# UNITED STATES PATENT AND TRADEMARK OFFICE

APPLICATION NO.	FILING DATE	FIRST NAMED INVENTOR	ATTORNEY DOCKET NO.	CONFIRMATION NO.
10/026,450	12/27/2001	Hayato Minamishin	011734	1596

# Office Action Summary

## **DETAILED ACTION**

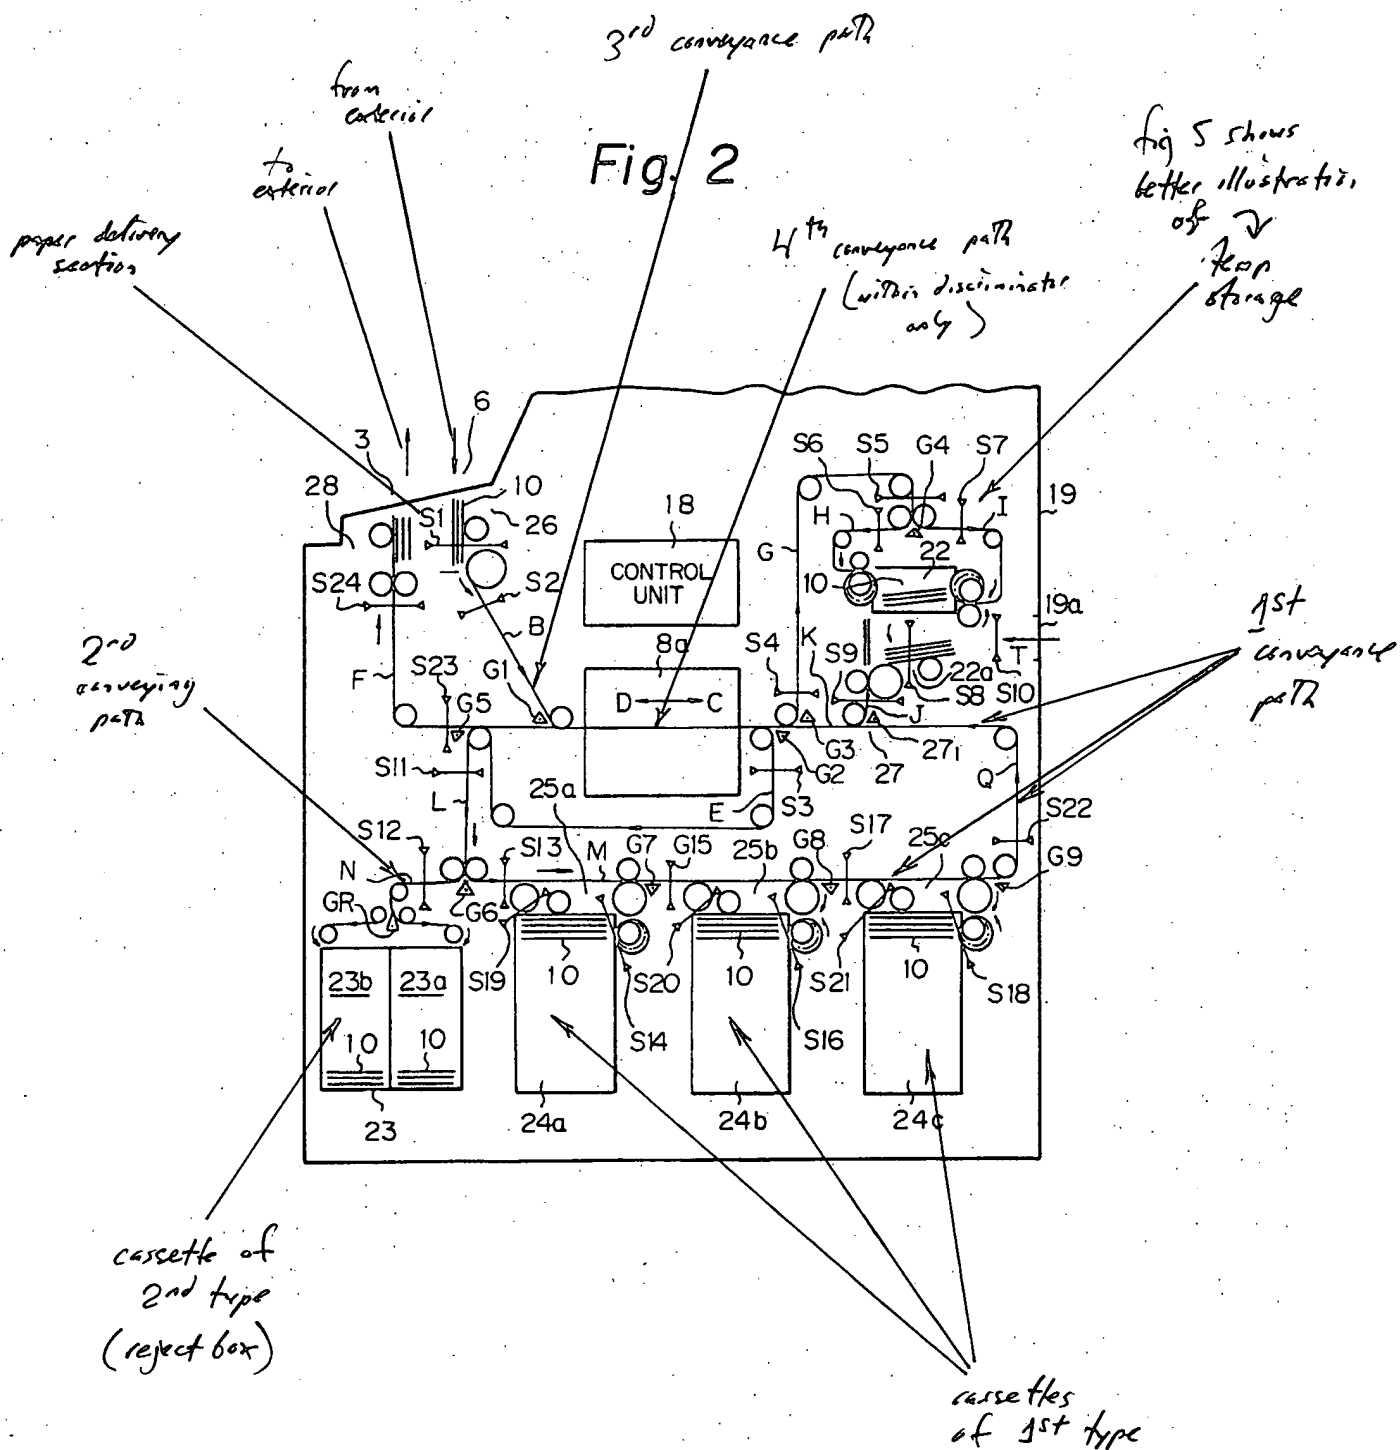
Claims 1-12 are rejected under 35 U.S.C. 102(b) as being anticipated by US 4,625,870 to Nao.

On the following page, the Examiner has included a copy of figure 2 of Nao et al. with the conveyance paths, cassettes, and other pertinent elements clearly labeled. As all of the conveyance paths effectually feed directly or indirectly to all other conveyance paths and, eventually, to the exterior and the reject box, the functional recitations are inherent.

FIG. 2

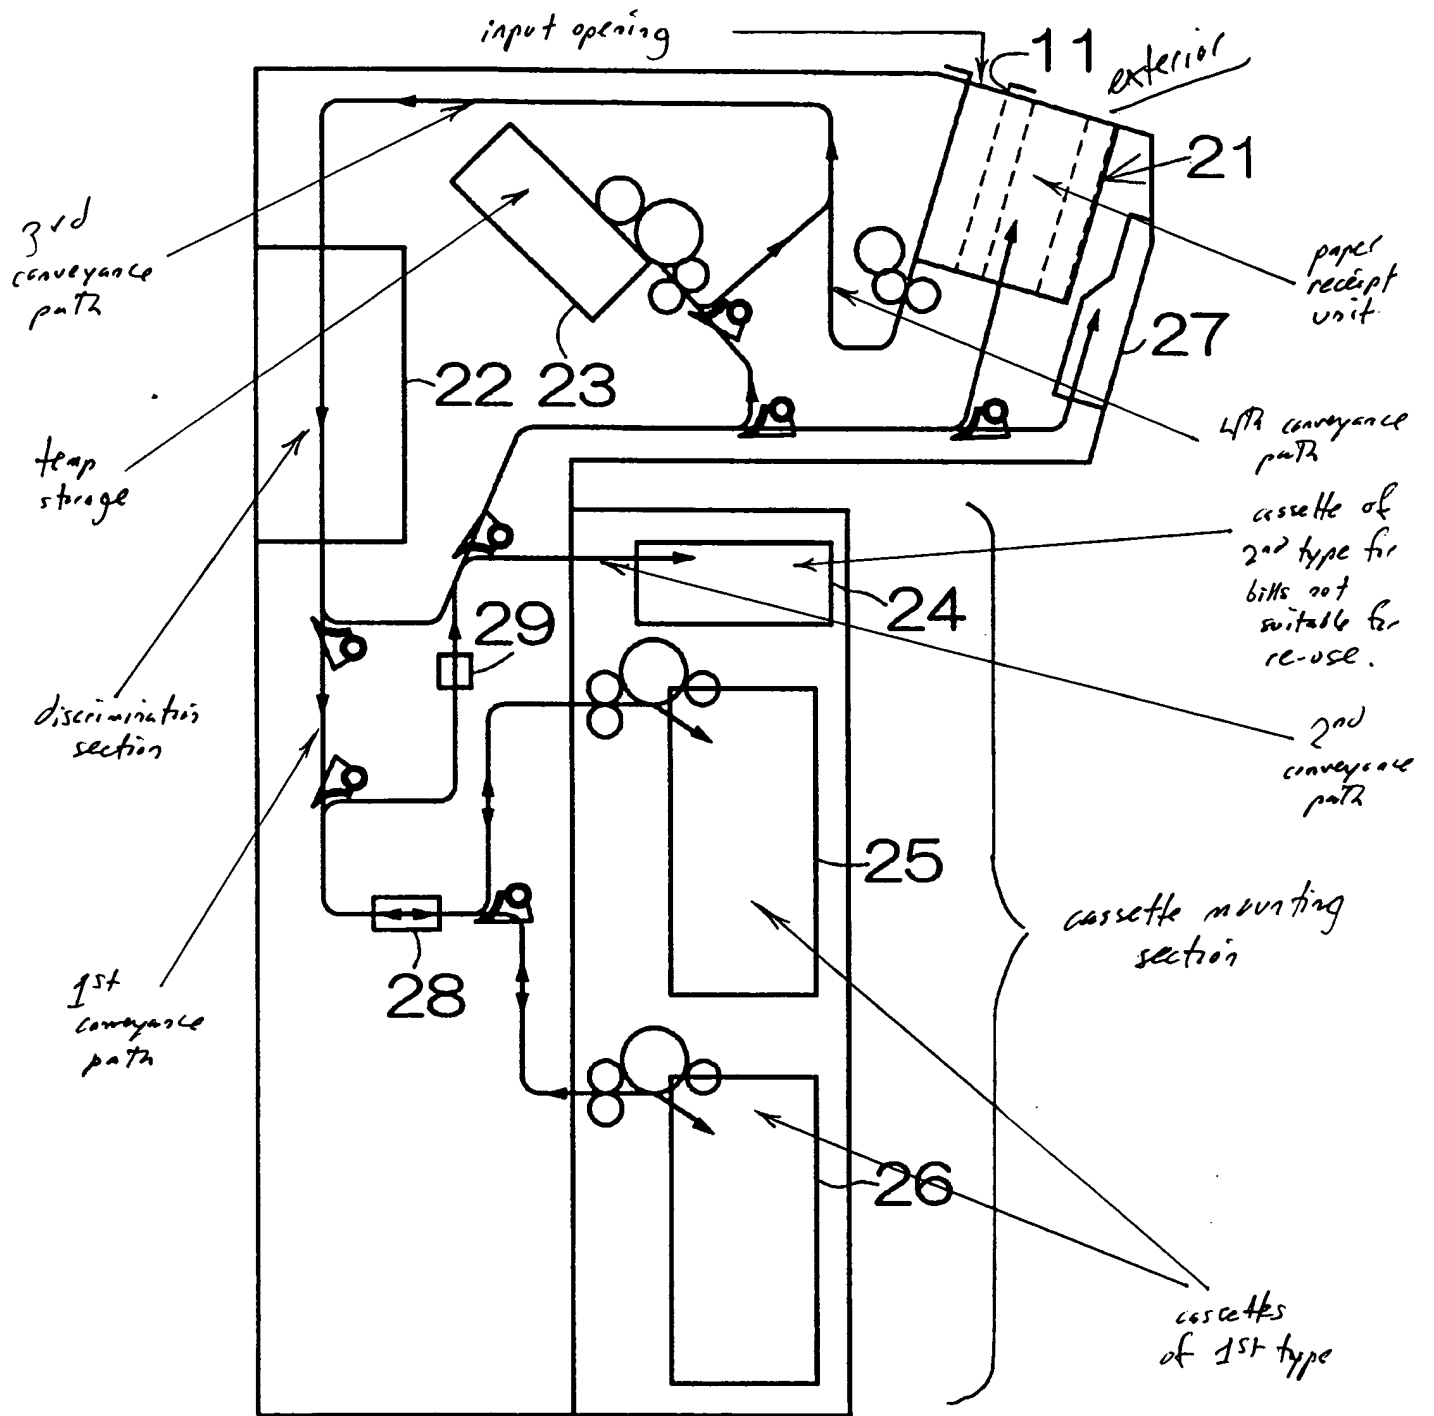
Claims 1-12 are rejected under 35 U.S.C. 102(e) as being anticipated by US 6,254,083 to Abe et al (different inventive entity).

On the following page, the Examiner has included a copy of figure 2 of Abe et al. with the conveyance paths, cassettes, and other pertinent elements clearly labeled. As all of the conveyance paths effectually feed directly or indirectly to all other conveyance paths and, eventually, to the exterior and the reject box, the functional recitations are inherent.
